ADDENDUM NO. 2

**TO THE CONTRACT DOCUMENTS FOR
Davis Pressure Plane Phase 2
PROJECT NO. WUWS17001**

November 12, 2021

MEDIAN NOSE PAVERS
NTS REV: 7/18/17

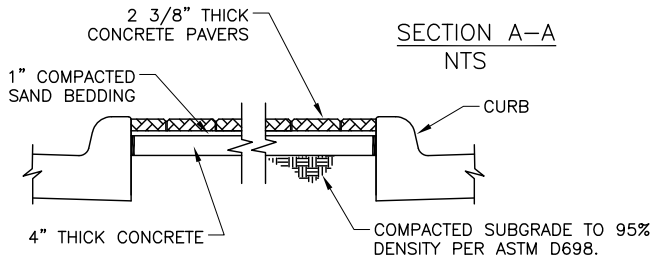
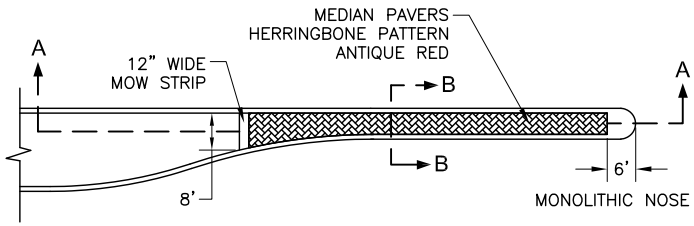
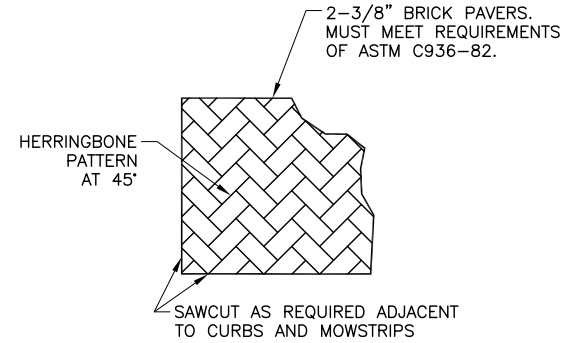
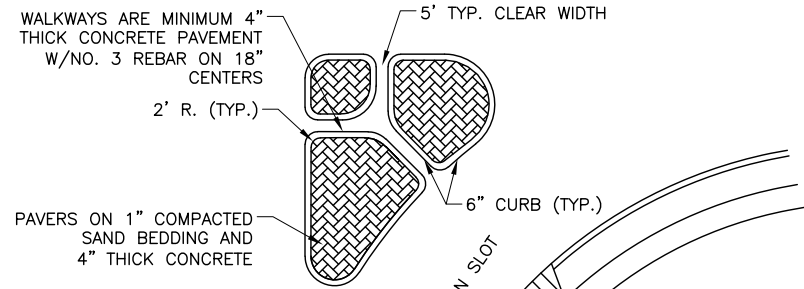
433	20 SY	Remove and Replace Brick Paver Nose with Concrete Monolithic Nose per MEDIAN NOSE PAVERS detail, complete and in place for the sum of _____ dollars and _____ cents per Square Yard.	\$	\$
-----	-------	---	----	----

- Attached MEDIAN NOSE PAVERS detail is added to Addendum #2 as part of the details of this project.
